PCI-SIG ENGINEERING CHANGE NOTICE

TITLE:	Latency Tolerance Reporting
DATE:	22 January 2008, updated 14 August 2008
AFFECTED DOCUMENTS:	PCI Express Base Specification version 2.0
SPONSORS:	Intel

Figure <LTR2>: Latency Fields Format for LTR Messages

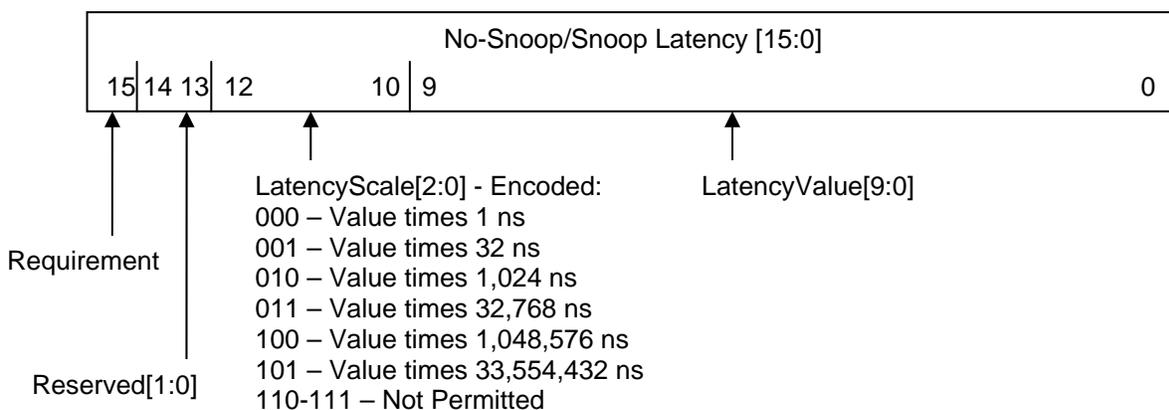
No-Snoop Latency & Snoop Latency: As shown in Figure <LTR2>, these fields include a Requirement bit that indicates if the device has a latency requirement for the given type of Request. With any LTR Message transmission, it is permitted for a device to indicate that a requirement is being reported for only no-snoop Requests, for only snoop Requests, or for both types of Requests. It is also permitted for a device to indicate that it has no requirement for either type of traffic, which it does by clearing the Requirement bit in both fields.

Each field also includes value and scale fields that encode the reported latency. Values are multiplied by the indicated scale to yield an absolute time value, expressible in a range from 1 ns to $2^{25} \times (2^{10} - 1) = 34,326,183,936$ ns.

Setting the value and scale fields to all 0's indicates that the device will be impacted by any delay and that the best possible service is requested.

If a device doesn't implement or has no service requirements for a particular type of traffic, then it must have the Requirement bit clear for the associated latency field.

Figure <LTR3>: CLKREQ# and Clock Power Management

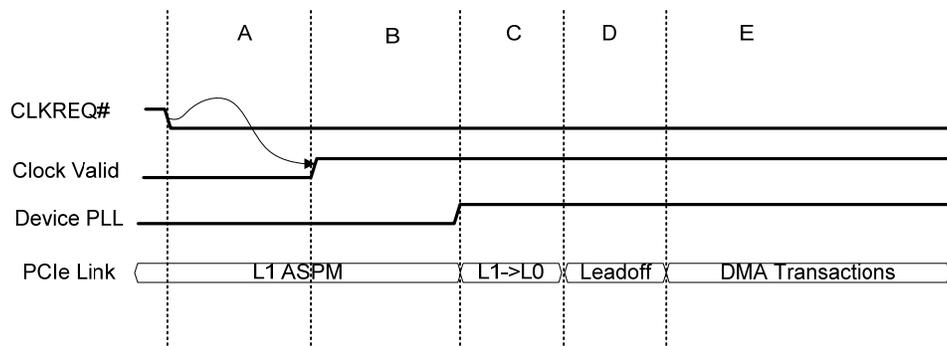
Time A is a platform implementation-dependent period between when a device asserts CLKREQ# and the device receives a valid clock signal. This value will not exceed the latency in effect.

Time B is the device implementation-dependent period between when a device has a valid clock and it can initiate the retraining sequence to transition from L1 ASPM to L0.

Time C is the period during which the transition from L1 ASPM to L0 takes place. This value will not exceed the maximum L1 exit latency reported by the Endpoint.

Time D for a Read transaction is the time between the transmission of the END symbol in the Request TLP to the receipt of the STP symbol in the Completion TLP. Time D for a Write transaction is the time between the transmission of the END symbol of the TLP that exhausts FC credit to the receipt of the SDP symbol in the DLLP returning more credits. This value will not exceed the latency in effect.

Time E is the period where the data path from the Endpoint to system memory is open, and data transactions are not subject to the leadoff latency.

Case 1: the device may or may not support Clock PM, but has not deasserted its CLKREQ# signal – The latency observed by the device is represented in Figure <LTR3> as time D.

Case 2: the device supports Clock PM and has deasserted CLKREQ#- The latency observed by the device is represented as the sum of times A and D.

To effectively use the LTR mechanism in conjunction with Clock PM, the device will know or be able to measure times B and C, so that it knows when to assert CLKREQ#. The actual values of Time A and Time D may vary dynamically, and it is the responsibility of the platform to ensure the sum will not exceed the latency.

Figure <LTR4>: Use of LTR and Clock Power Management

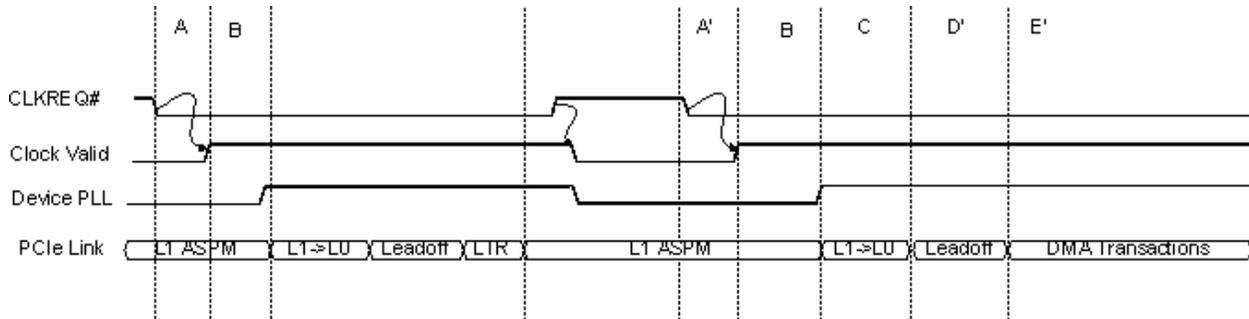
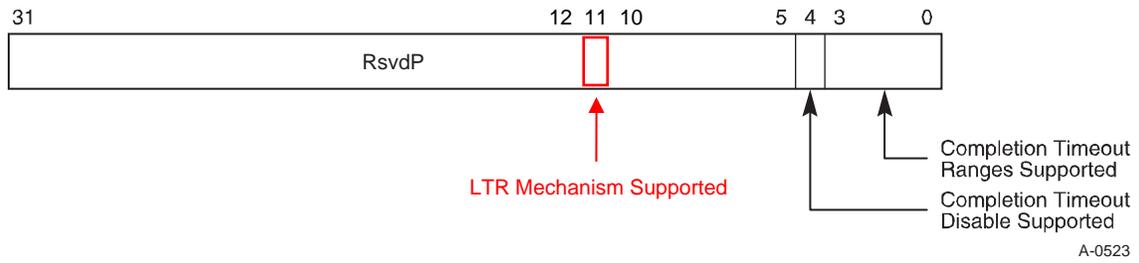
In a very simple model, an Endpoint may choose to implement LTR as shown in Figure <LTR4>. When an Endpoint determines that it is idle, it sends an LTR Message with the software configured maximum latency or the maximum latency the Endpoint can support.

When the Endpoint determines that it has a need to maintain sustained data transfers with the Root Complex, the Endpoint sends a new LTR Message with a shorter latency (at Time E). This LTR Message is sent prior to the next data flush by a time equal to the maximum latency sent before (the time between Time E and Time D'). In between Time E and Time A', the Endpoint can return to a low power state, while the platform transitions to a state where it can provide the shorter latency when the device next needs to transmit data.
